Subject: Response to NRC Generic Letter 96-06
Cooper Nuclear Station, NRC Docket 50-298, DPR-46

**Response to NRC Electronic Request for Additional Information
Dated April 30, 2002**

Response to NRC Request for Additional Information NRC Letter dated April 24, 1998

**Attachment 3
Response to Generic Letter 96-06**

FIGURE 1

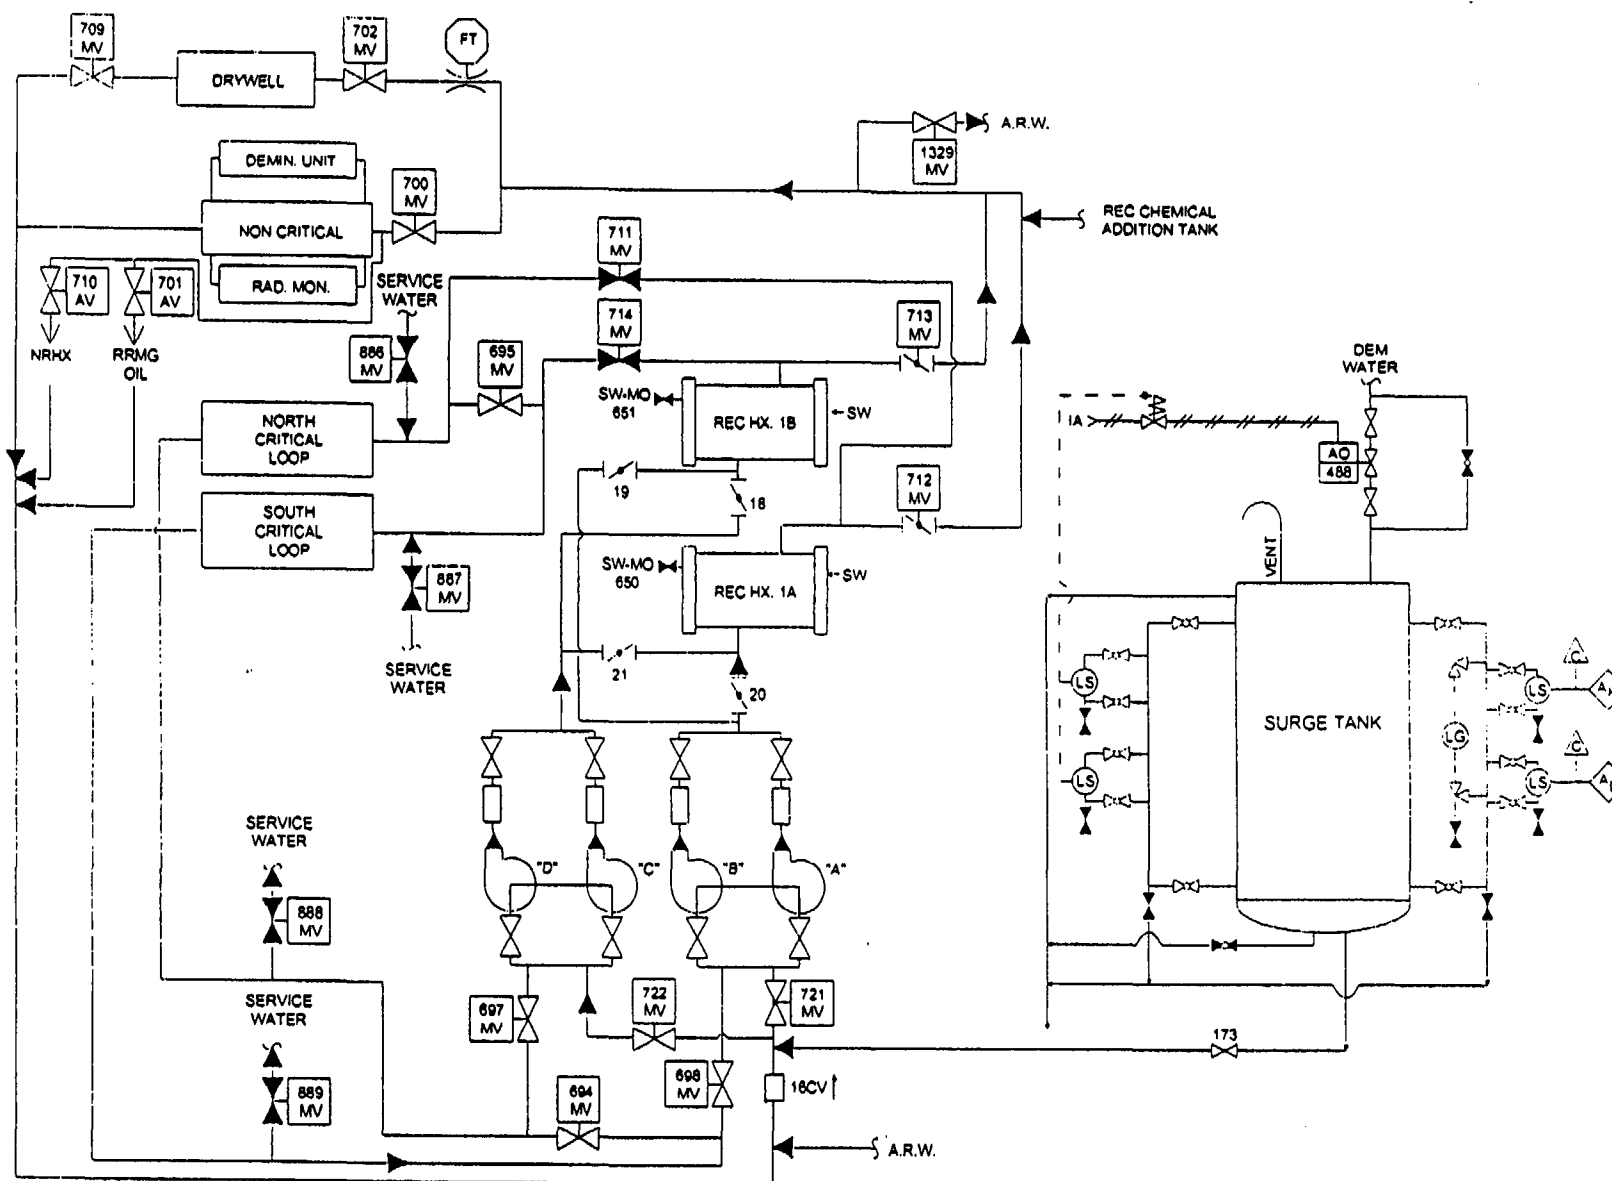
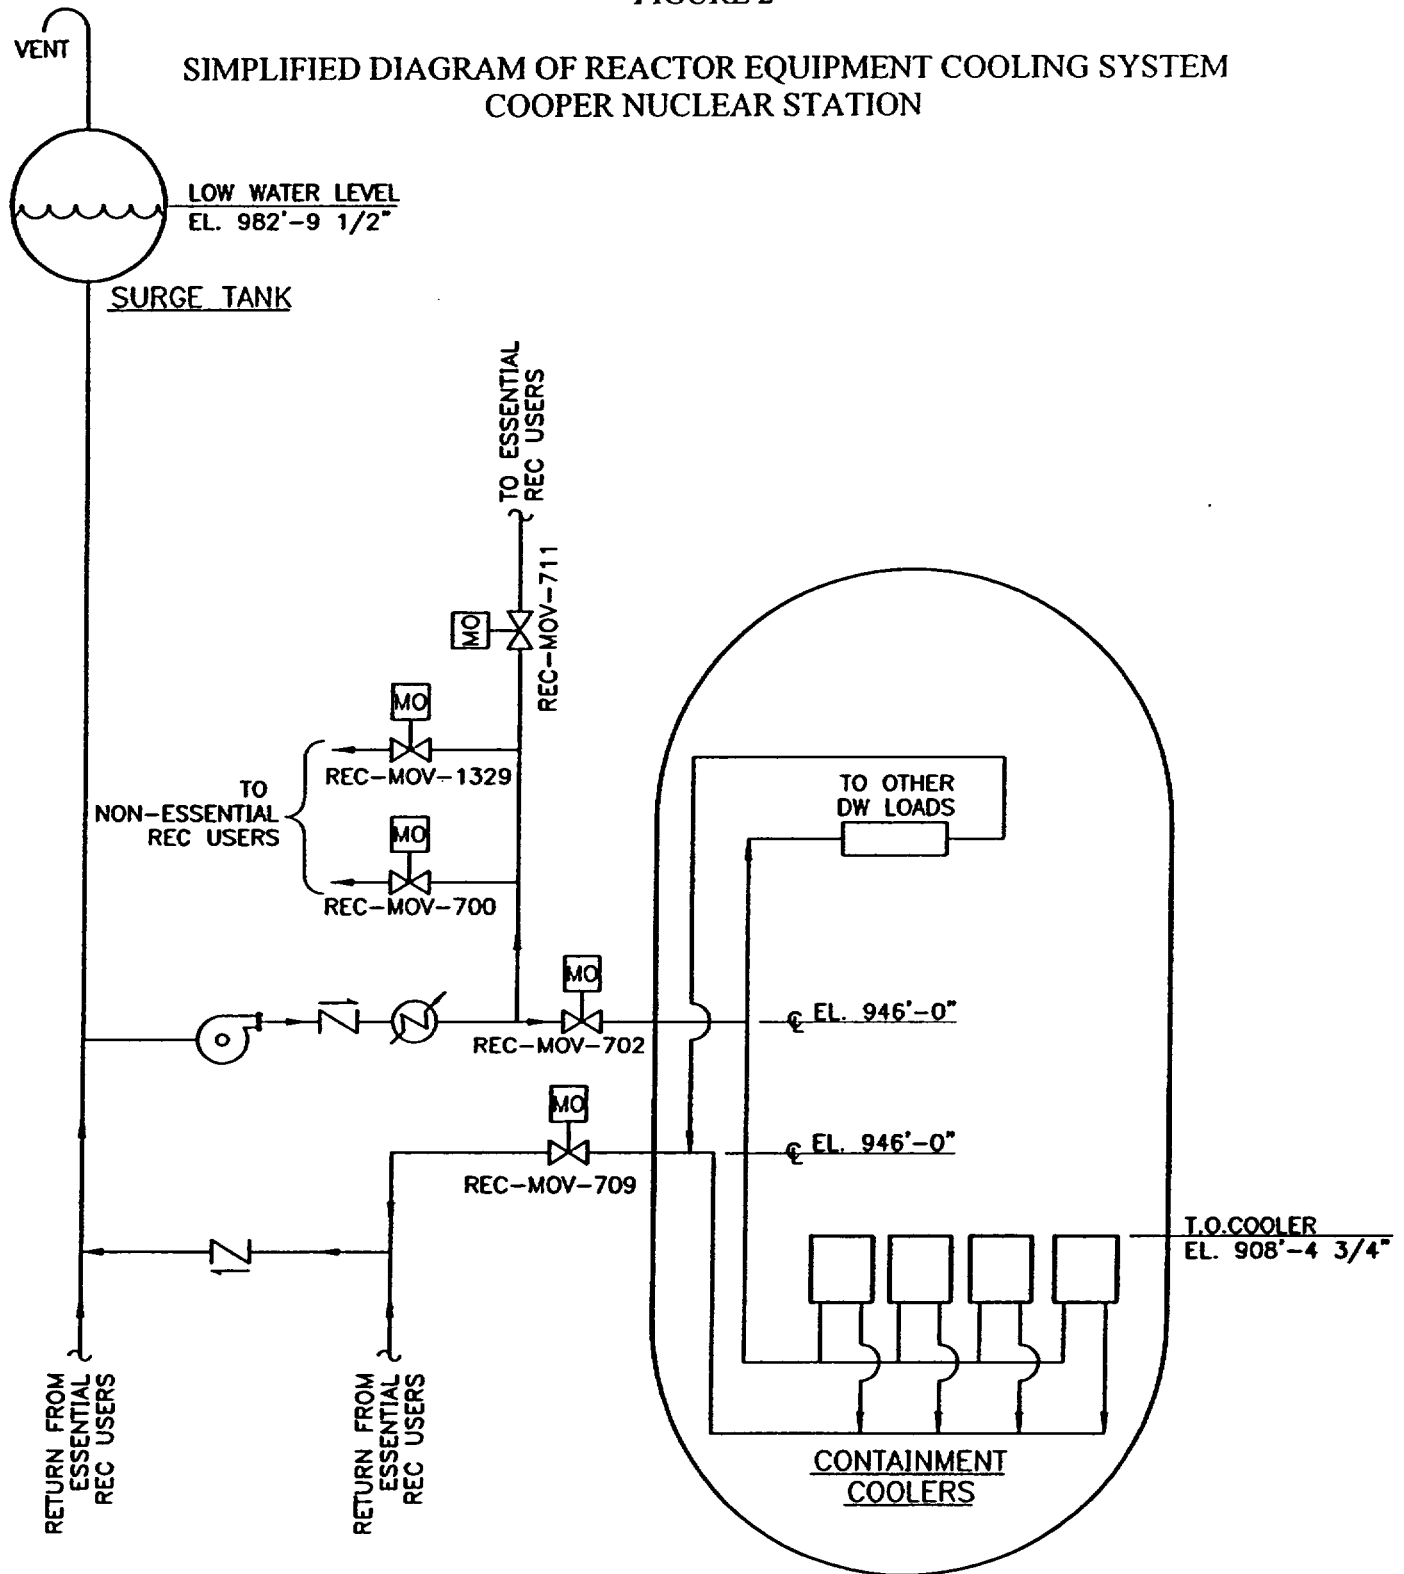
Provide a simplified diagram of the system, showing major components, active components, relative elevations, length of piping runs, and the location of any orifices and flow restrictions.

A simplified flow diagram of the REC System showing the major and active components is provided as Figure 1. A simplified diagram showing the elevations of the major components is provided as Figure 2. (The box in Figure 2 entitled "Other DW loads" represents loads that are located both above and below the coolers. For simplicity of the figure these elevations are not shown.) The lengths of piping runs are not shown in Figure 2 since CNS considers the lengths of piping runs in the REC System as having little or no impact on the applicable analyses.
